Town of Maynard

January 13, 2026 Planning Board Meeting

PROJECT NAME 151 Main Street

Peer Review Comment Form

SITE DEVELOPMENT PLAN
FOR: MATTHEW HALL
SCALE: 1"=20' OCTOBER 9, 2025
 REVISED: DEC 4, 2025

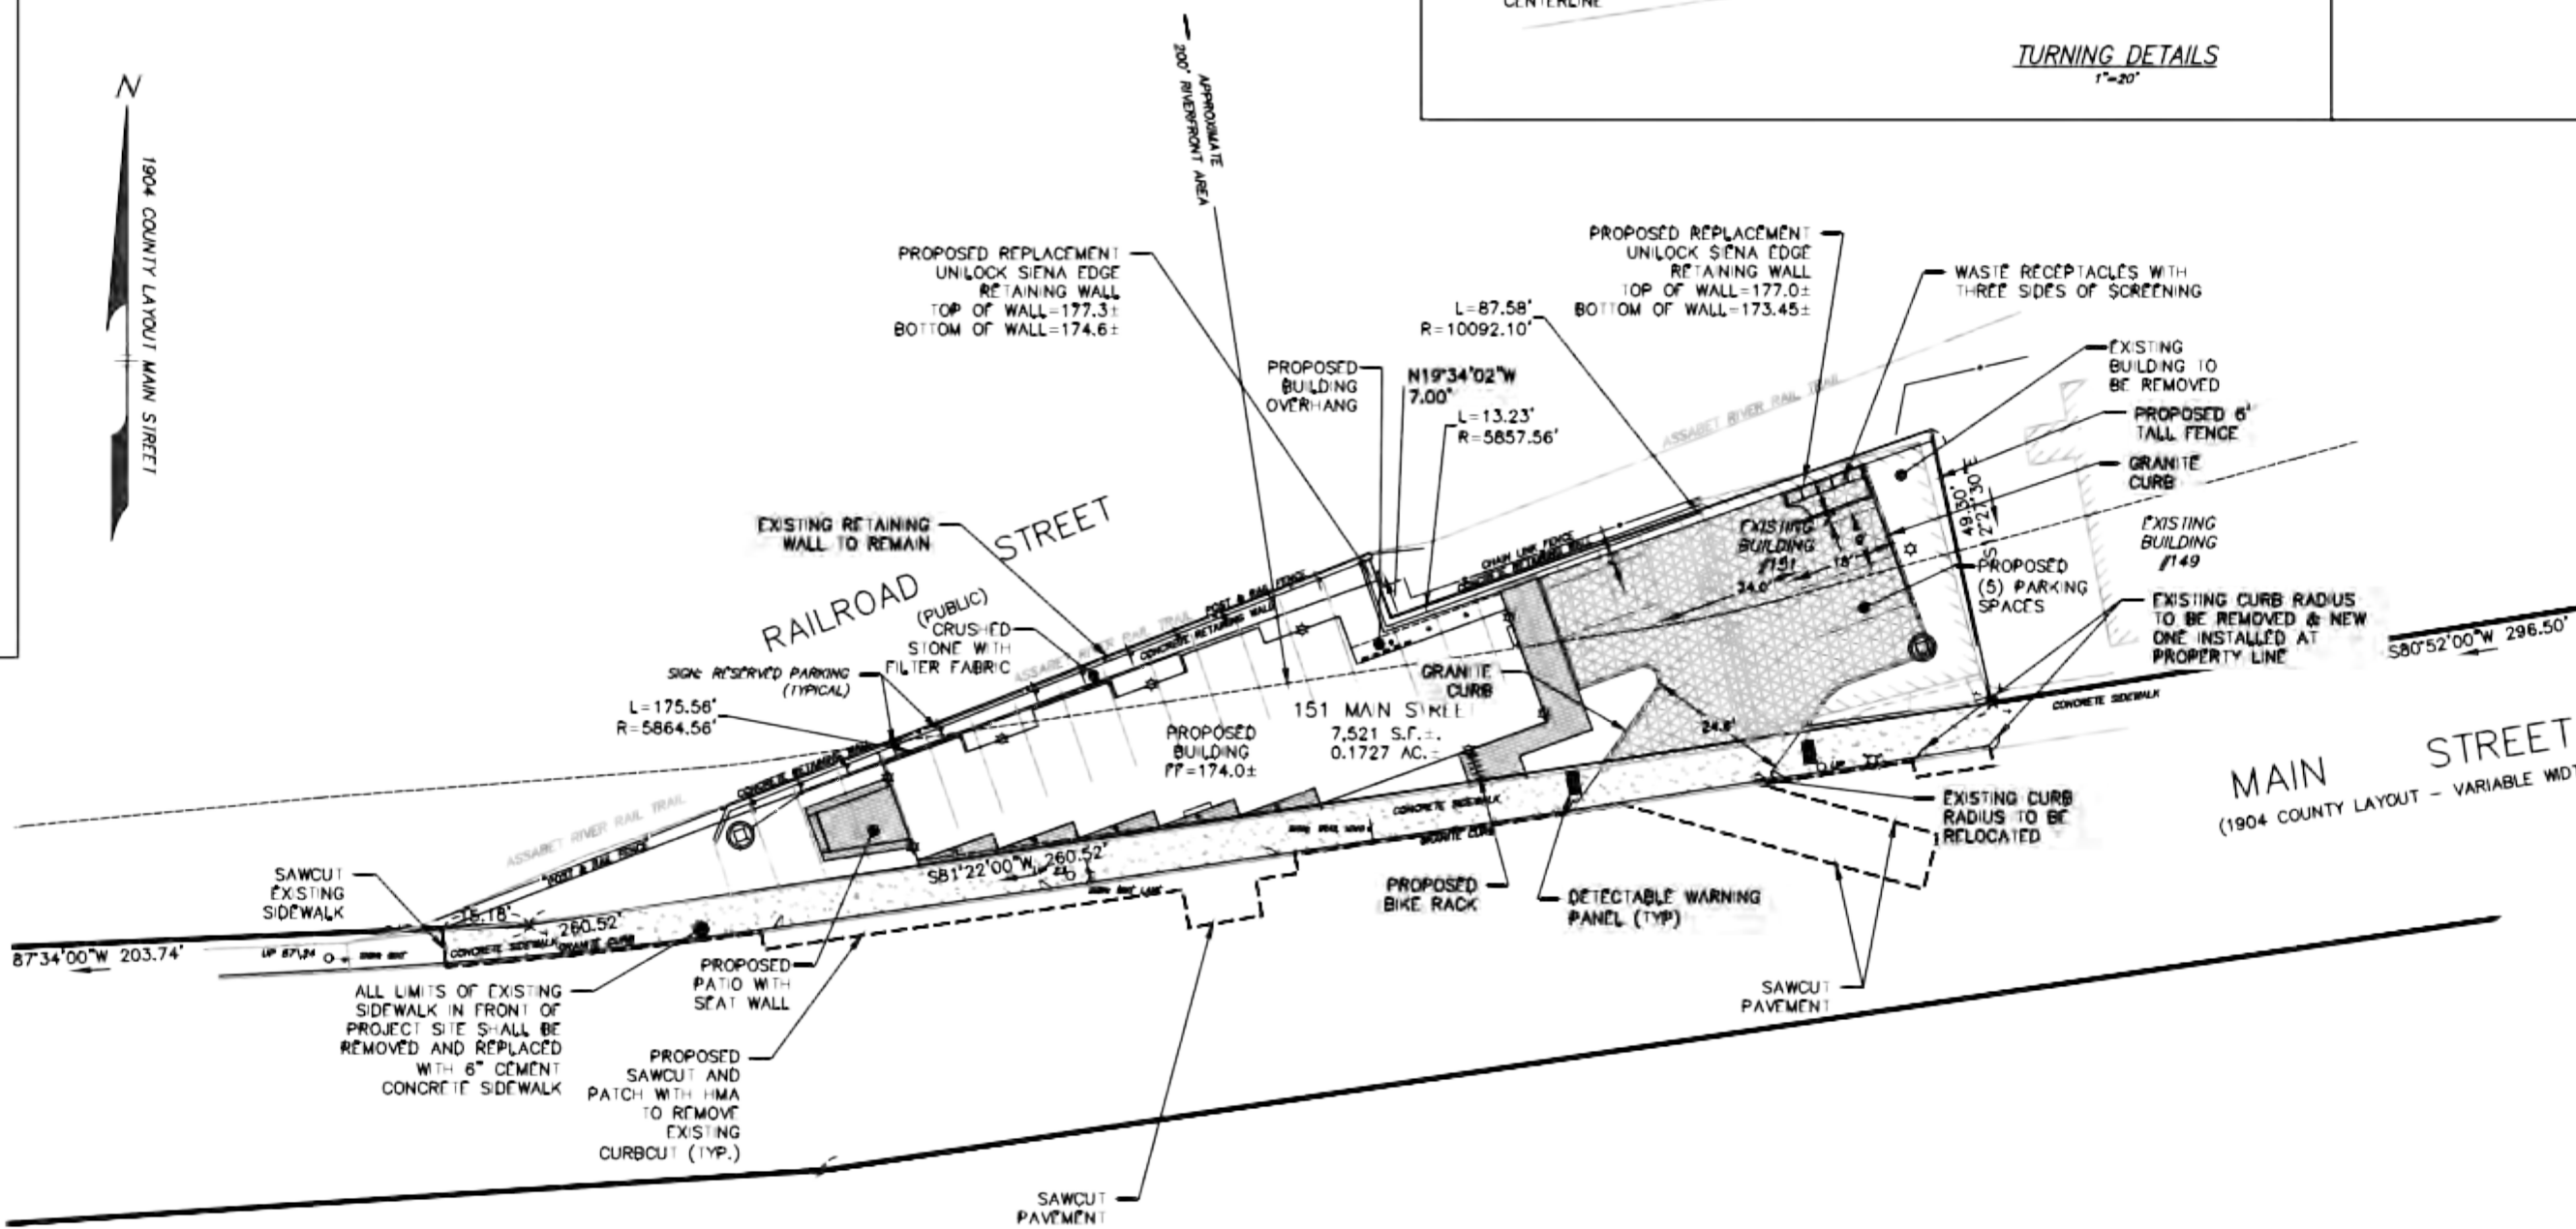
5	Site Development Plan		A cape cod berm and granite curb is proposed in the parking lot. A granite curb is recommended to hold up better against snow plows. Please consider revising.	All curbing is now proposed as granite.	VR	12/9/2025
6	Site Development Plan		It is recommended that the curb line on the eastern portion of the site moves the curb cut to the property line since the old curb cut for the garage door is no longer needed. Please consider revising.	The existing curb cut on the eastern portion of the site is now proposed to be moved to match the eastern edge of the frontage since there will be no garage there after this project is completed.	VR	12/9/2025
7	Site Development Plan		Is the existing wall being removed and replaced with a new wall or are the walls going to be next to each other? Any items to be removed should be called out on the plans. Proposed walls should be detailed on the plans with the existing walls if they are to remain. Please revise.	The rail trail retaining wall is to remain as is, and the other wall replaced with a unlock retaining wall. The labels for the walls have been updated.	JT	12/23/2025

Detail: Photometric Calculation

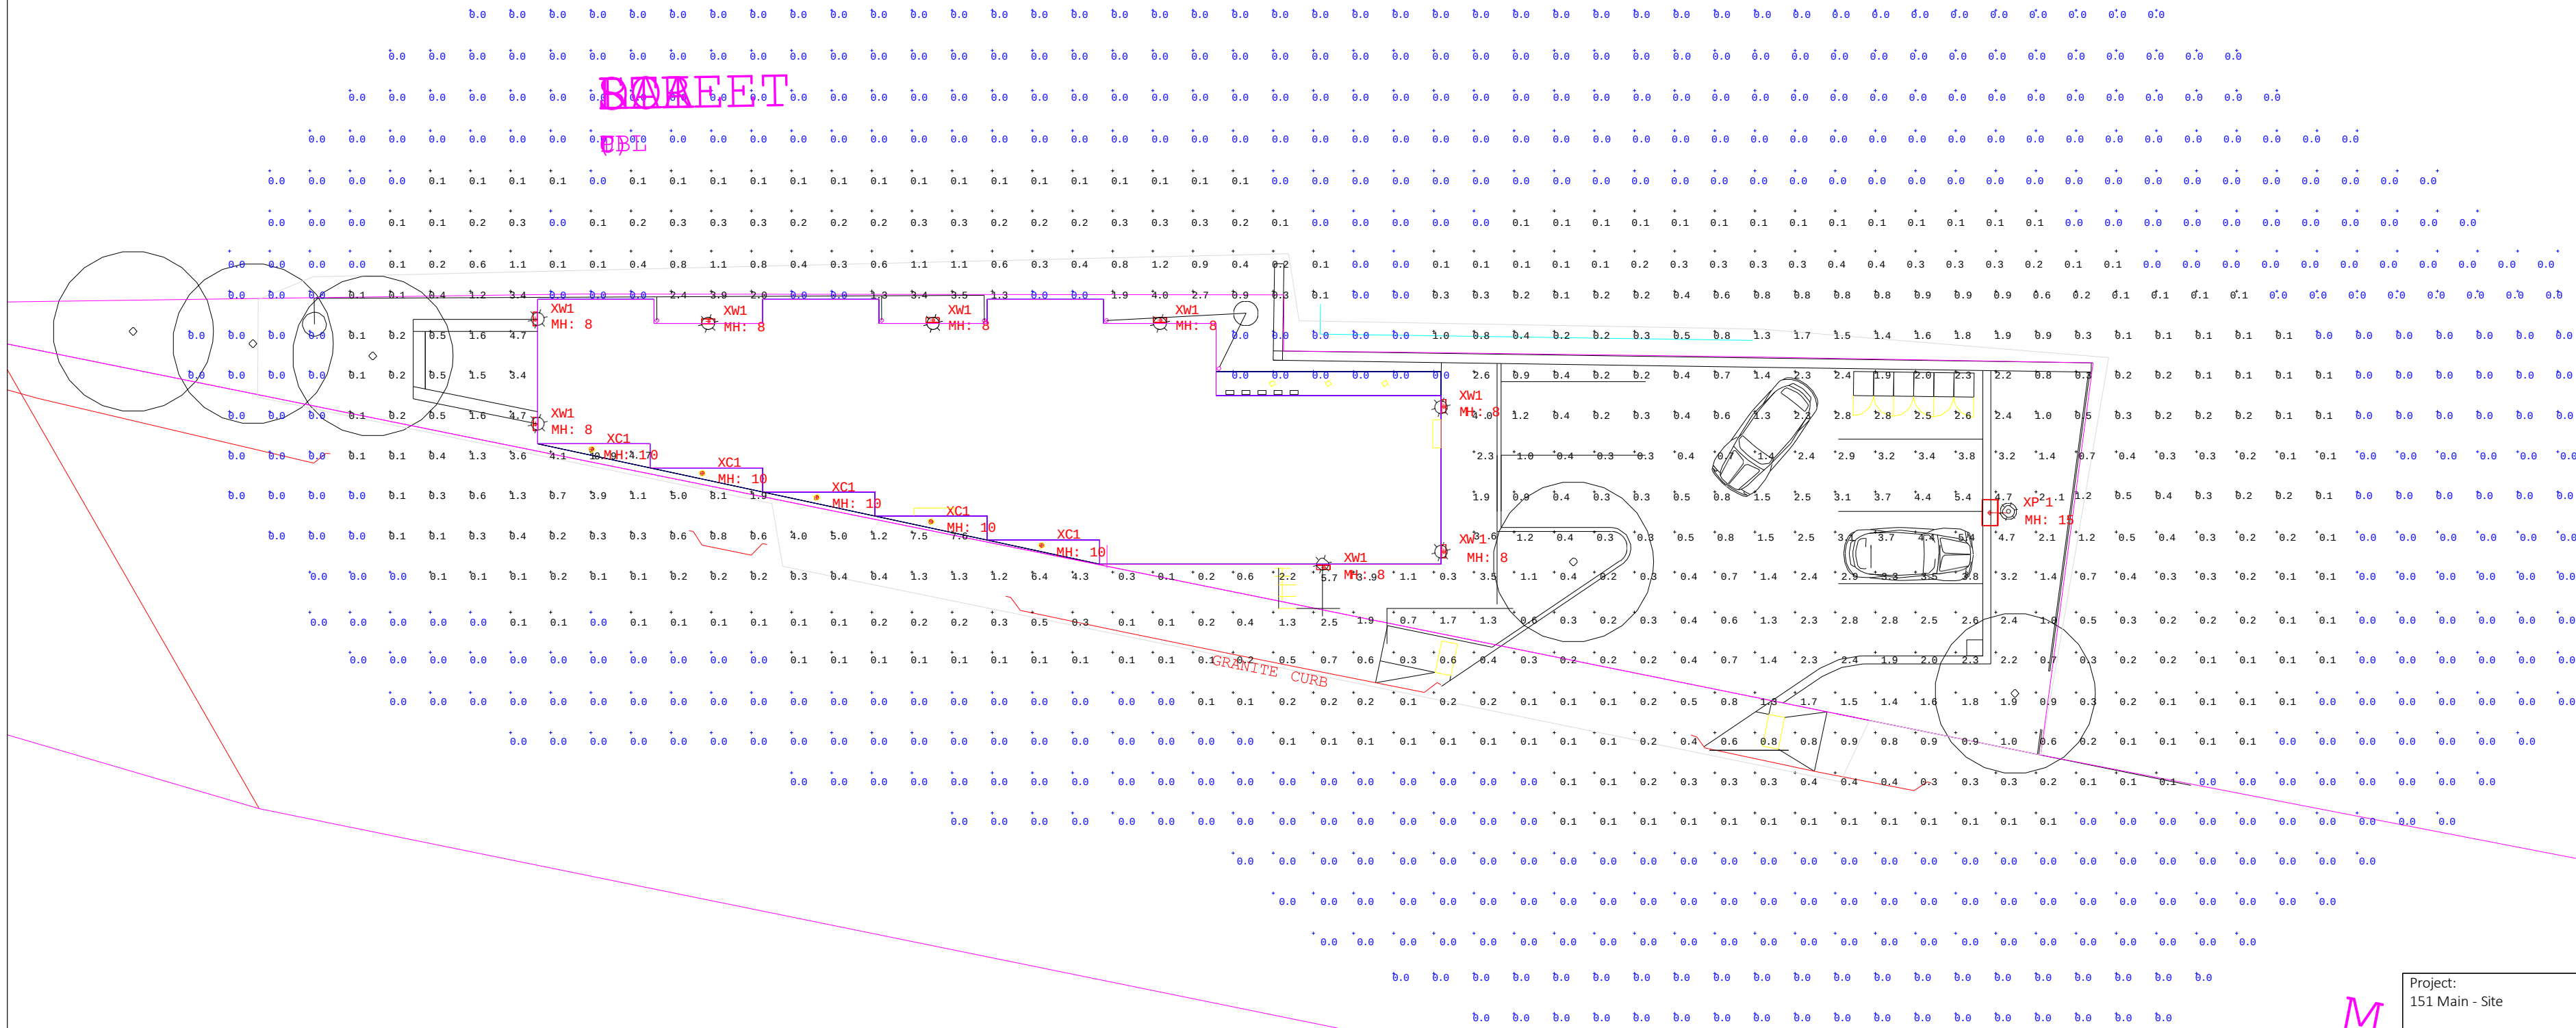
NO.	SHEET NO.	SECTION	GREEN'S COMMENT	Applicant's RESPONSE	CONFIRMED BY	DATE
30	Photometric Plan	PB Landscape Regs 5.9.2	Please confirm the shut off controls such as sensors, timers, and motion detectors to turn off lights when not needed.	Exterior lighting will be on timers located in mechanical area on the ground floor	JT	12/23/2025
31	Photometric Plan	PB Landscape Regs 5.9.2	Light spill across the property lines should not exceed 0.1 foot candles adjacent to business properties. The current light spill on the adjacent property to the east exceeds 0.1 foot candles. Please revise.	Please see PB comments regarding light levels at entries and north side.		
31A	Photometric Plan	PB Landscape Regs 5.9.2	We defer to the Board for approval.			
32	Photometric Plan	PB Landscape Regs 5.9.2	It is recommended that at building entrances and sidewalks foot candles do not exceed 5 fc. Please revise.	Please see PB comments regarding light levels at entries and north side.

32A	Photometric Plan	PB Landscape Regs 5.9.2	We defer to the Board for approval.			
33		Stormwater Management Regulations 7.A	The required stormwater treatment volume was not provided. Therefore, it is assumed that the project disturbs less than 10,000 sf. Please confirm the square feet of disturbed area is less than 10,000 sf or provide the required and provided stormwater treatment.	The project disturbs less than 10,000 square feet (the entire lot is only 7,521 square feet).	VR	12/10/2025

SITE PLAN
151 MAIN STREET
IN
MAYNARD, MASSACHUSETTS
(MIDDLESEX COUNTY)
UTILITY PLAN

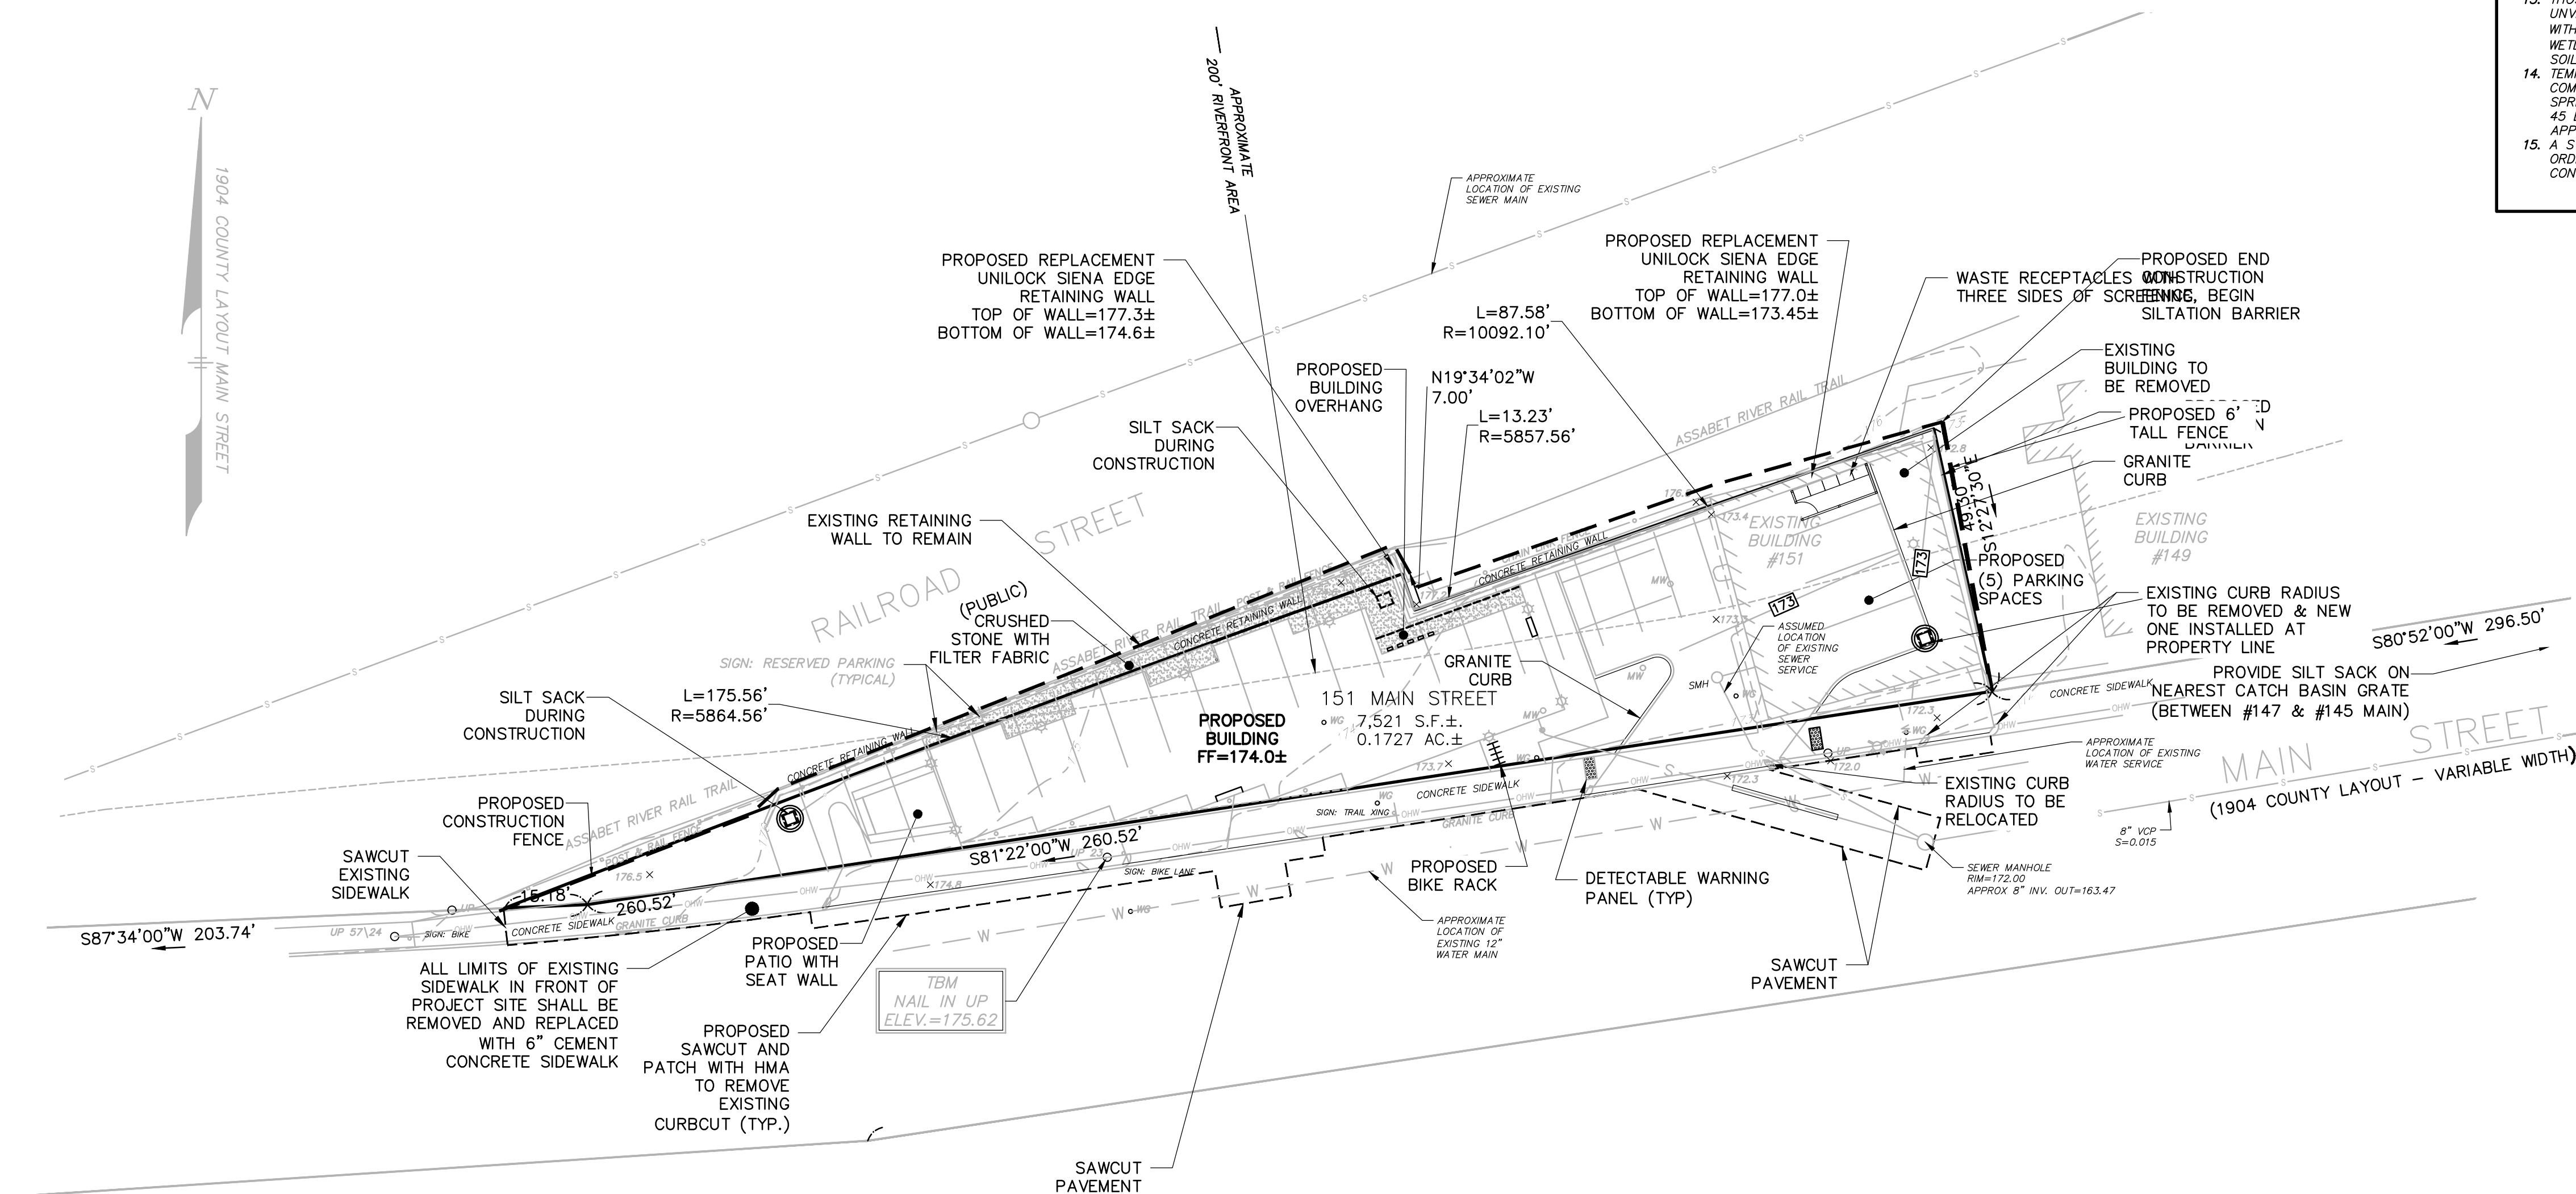
14	Utility Plan	PB Rules & Regs C.9	Has a system capacity analysis been performed and submitted to the DPW?	The DPW has confirmed adequate capacity for this project in terms of water demand.		
14A	Utility Plan	PB Rules & Regs C.9	We defer to the DPW for approval.			
15	Utility Plan	PB Rules & Regs H.3	Has the project been reviewed by the Fire Department to confirm how fire alarm and terminal boxes shall be installed and for fire access to the site?	The fire alarm and terminal box layout has not yet been finalized but will be coordinated with the Maynard Fire Department.

NO.	SHEET NO.	SECTION	GREEN'S COMMENT	Applicant's RESPONSE	CONFIRMED BY	DATE
15A	Utility Plan	PB Rules & Regs H.3	We recommend this be made a condition of approval.			
16	Utility Plan		The WATER MAIN CONNECTION DETAIL shows both an 8" and a 12" existing water main, please clarify. This also only seems to be a detail for the fire protection line, please revise or provide additional detail to also show the 2" domestic service. Also, the plan indicates a cut in tee but the detail indicates a tapping sleeve and valve. Please confirm with the DPW on the preferred connection.	The detail has been corrected to note the water main as 12". The detail has also been added to say "or 2" domestic".		
16A	Utility Plan		We defer to the DPW for approval.			
17	Utility Plan		Have test pits been performed to confirm soils are suitable for infiltration and the seasonal high groundwater is at least 2' below the bottom of the leaching basin? The soil onsite is potentially contaminated. Have soil sampling been performed to confirm the contamination of the soil is ok for infiltration BMPs? This should be sampled and confirmed by an Licensed Site Professional (LSP).	No, site is covered by Building and paving. Construction of the rail trail at the west corner did not encounter contaminants.	JT	12/23/2025

17A	Utility Plan		Based on the Planning Board Hearing, the Engineer is responsible for confirming the leaching basin has adequate separation to groundwater so, the BMP will function properly.		JT	12/23/2025
18	Utility Plan		WATER & SEWER CROSSING DETAIL the detail does not match what is shown in the plan. In the detail, the water main has the sleeve, but in the plans the sewer has a sleeve. Typically the sewer is encased at the crossings. Please clarify.	The detail has been corrected with the water and sewer pipe labels swapped to accurately reflect how the sewer line is proposed to be encased at the water crossing.	VR	12/9/2025
19	Utility Plan		How will the sewer manhole and pipe be abandoned? Will it filled and plugged at the active manhole?	The DPW has requested that the sewer manhole be removed. The pipe can be abandoned in place or removed from site if encountered during construction.	JT	12/23/2025

20	Utility Plan		It is not recommended to have an infiltration BMP such as the leaching basin within 10 feet of a building even if it is on a slab foundation. Please consider revising.	The leaching catch basin behind the proposed building has been removed.	VR	12/9/2025
21	Utility Plan		A detail for the crushed stone in the rear of the building should be provided. It is unclear from the grading, is this area able to drain out to the east behind the building?	Added a dispersion trench detail for the rear of building, surface flow graded to drain out	VR	12/10/2025
22	Stormwater Pollution Prevention Plan		Please indicate on the plans where each erosion control measure is being proposed.	Sheet 6 of the plan set shows a construction fence around the whole area of work, except for where a siltation barrier is proposed along the eastern edge of the project. Most of the site is downgradient of the neighboring areas except for this eastern portion. Additionally, silt sacks are proposed within the on-site proposed catch basins as well as in the existing catch basin between #145 and #147 Main Street (label with arrow on plan).	JT	12/23/2025
